DEVELOPMENT REVIEW COORDINATOR  
POST APPROVAL PROJECT CHECKLIST

Project Name: 433 Canal Plaza Hotel Permit # 2012-65556

Project Name: Canal Plaza Hotel  
Address: 433 Fore Street  
Applicant: Cow Plaza Hotel, LLC, Applicant  
Planner: Nell Donaldson

On November 5, 2012, the Planning Board considered your application for an 80,000 SF development, the Canal Plaza Hotel, at 433 Fore Street. The Planning Board reviewed the proposal for conformance with the site plan standards of the city's land use code and voted to approve the application with the waivers and conditions as presented below:

**HYATT PLACE PORTLAND - OLD PORT**  
**CMU WALL @ N.W. CORNER OF BLDG.**  
**GRADING MODIFICATION**

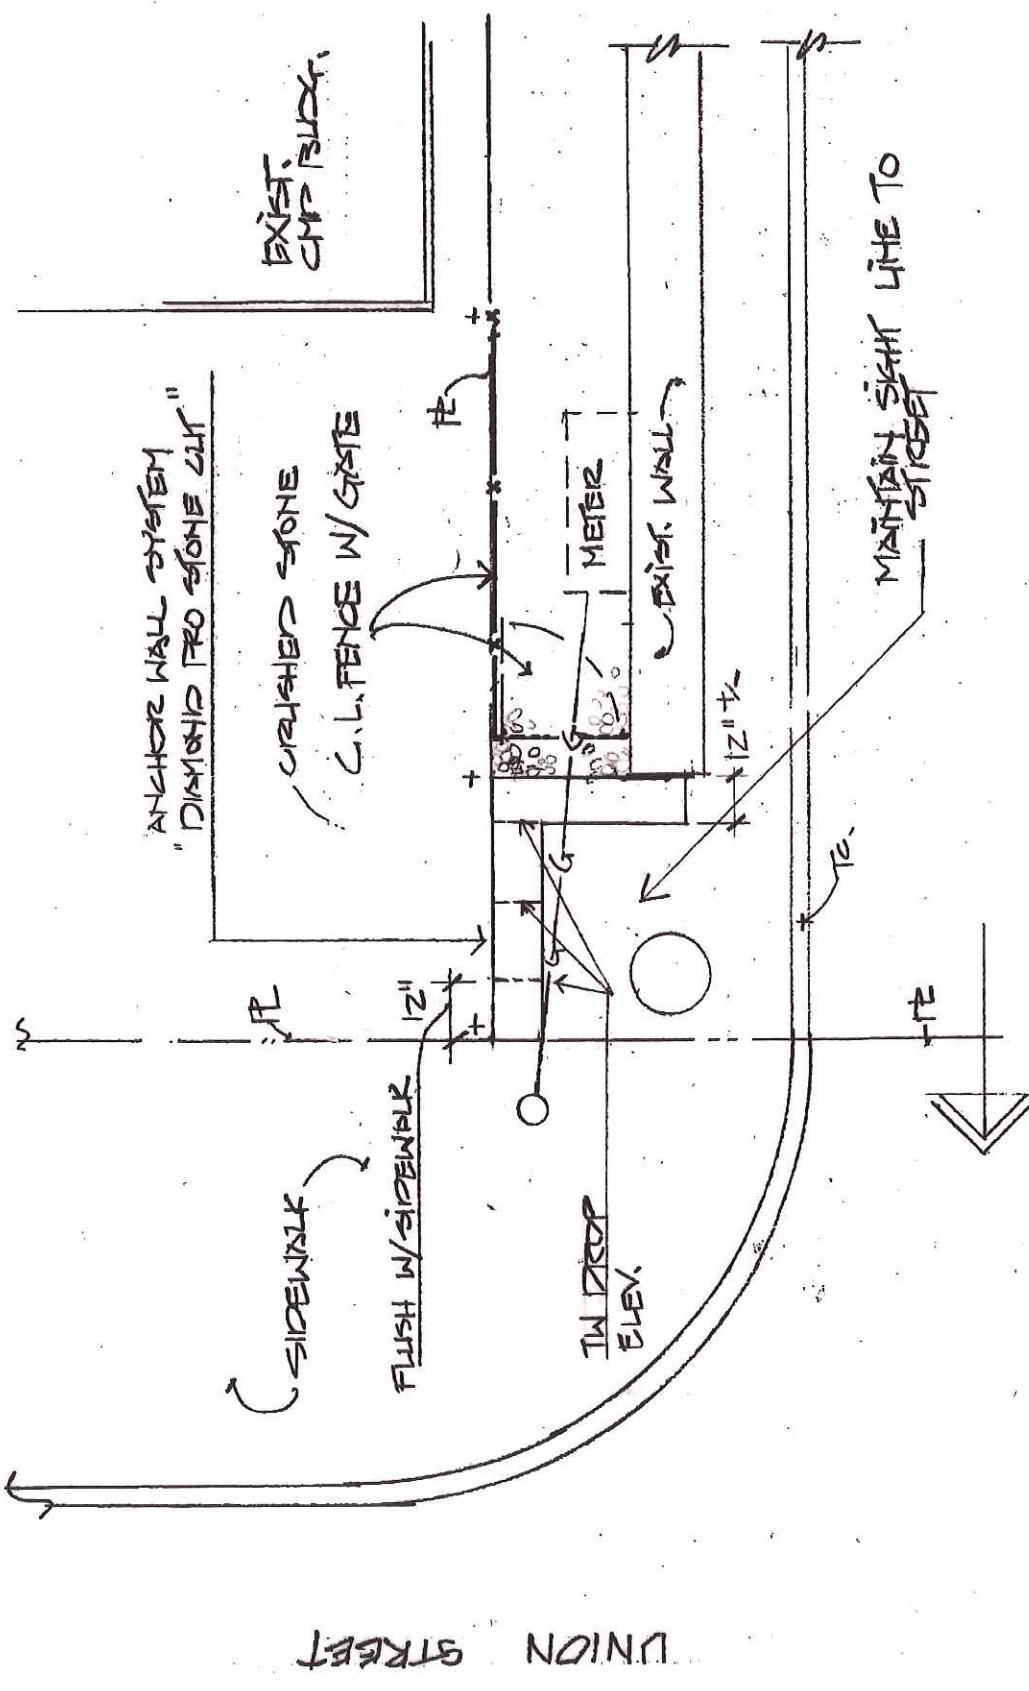
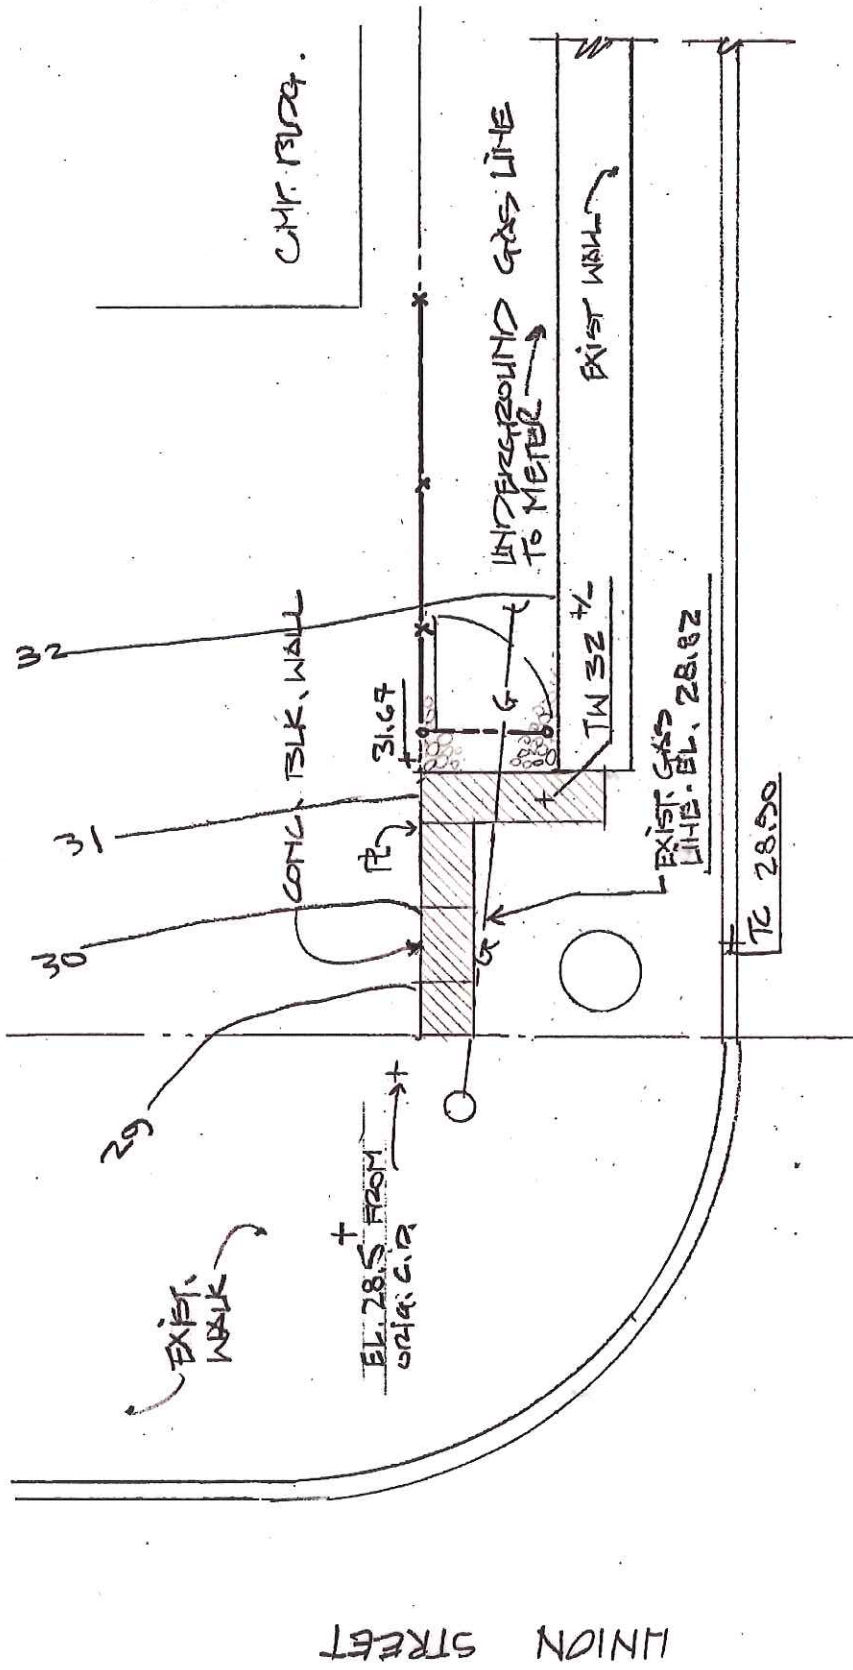
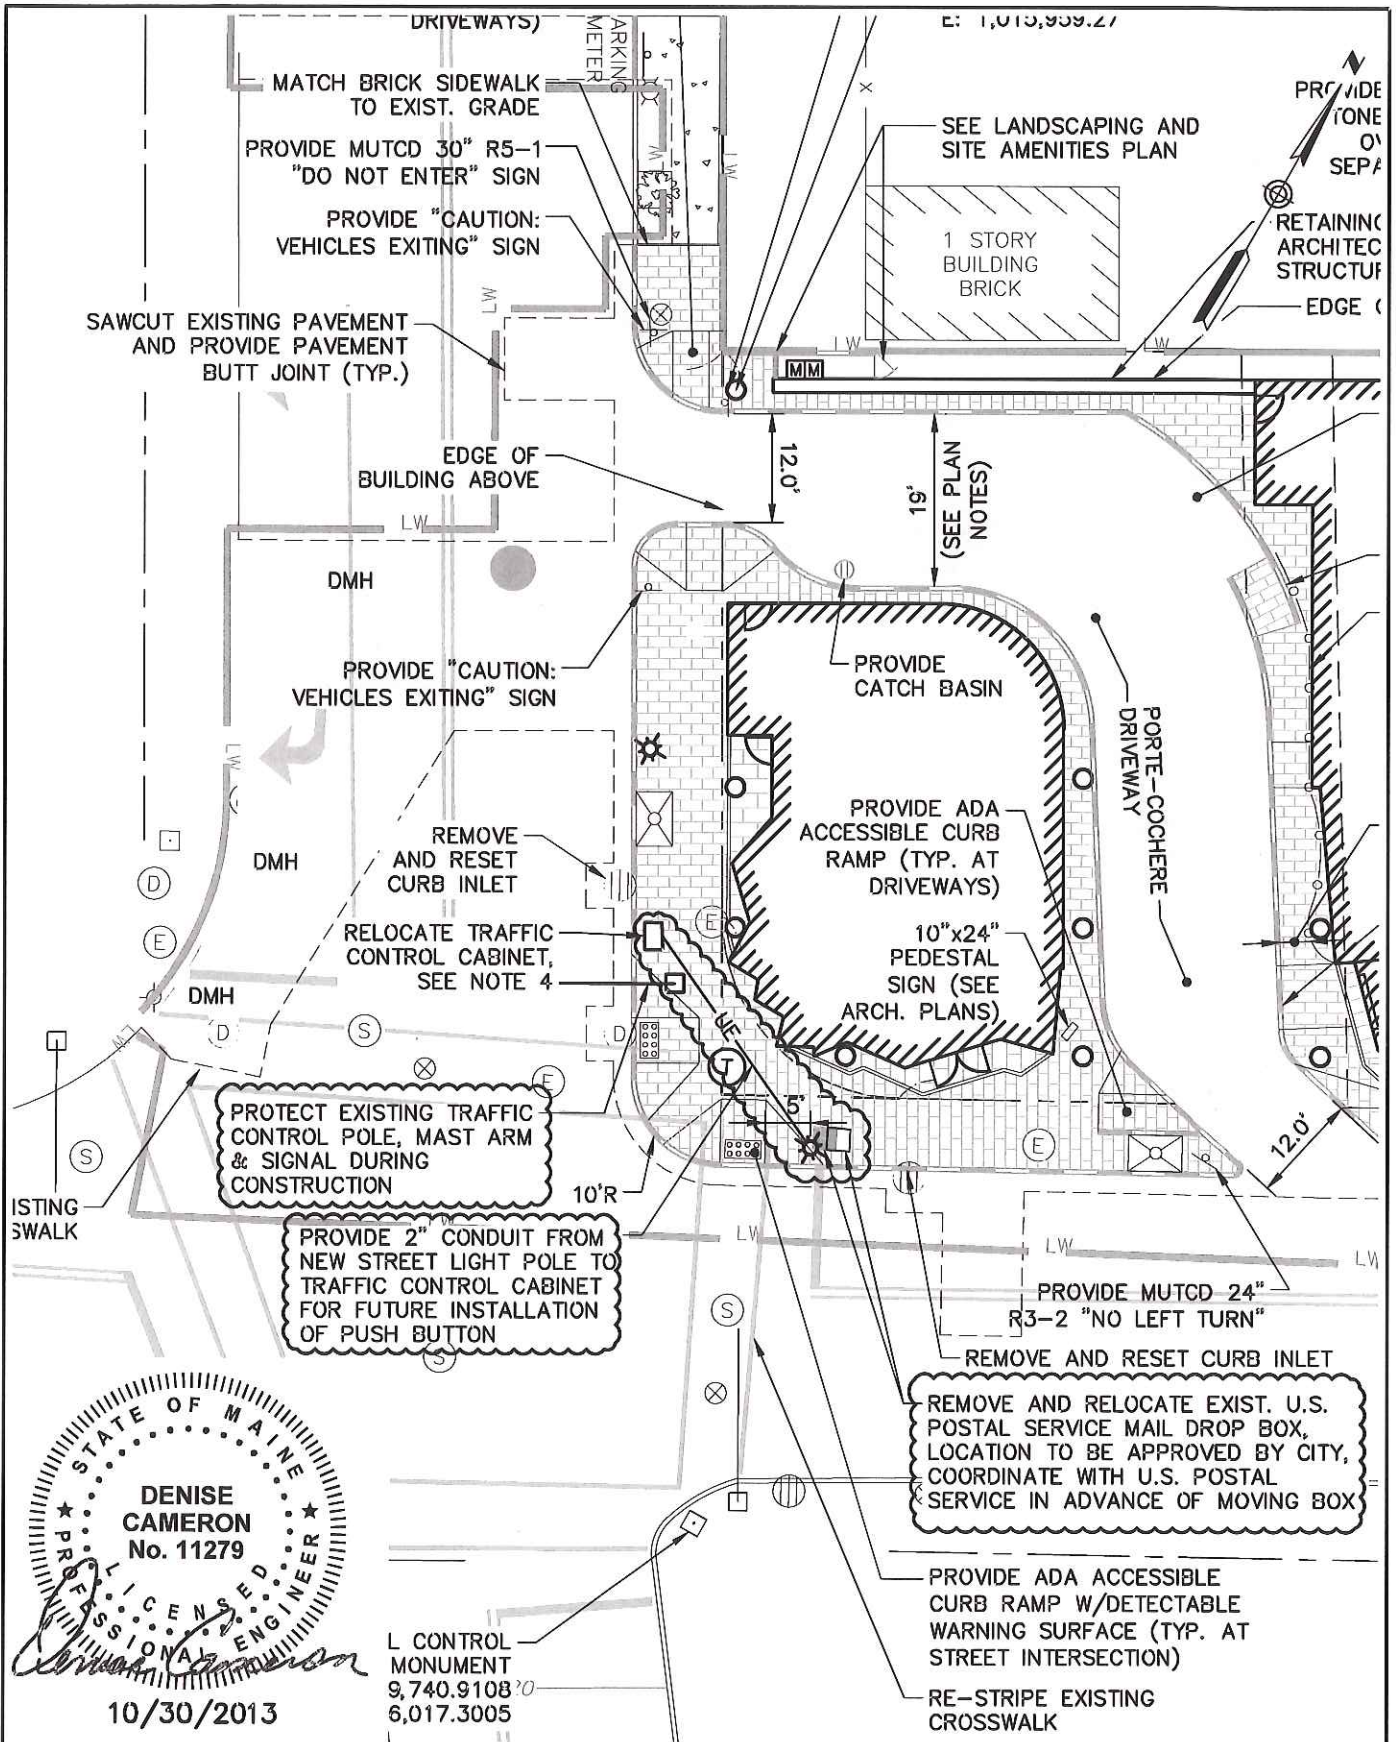
GRADING MODIFICATION @ N.W. CORNER OF BLDG:  
AT UNION STREET

GRADING MODIFICATION @ N.W. CORNER OF BLDG.  
AT UNION STREET
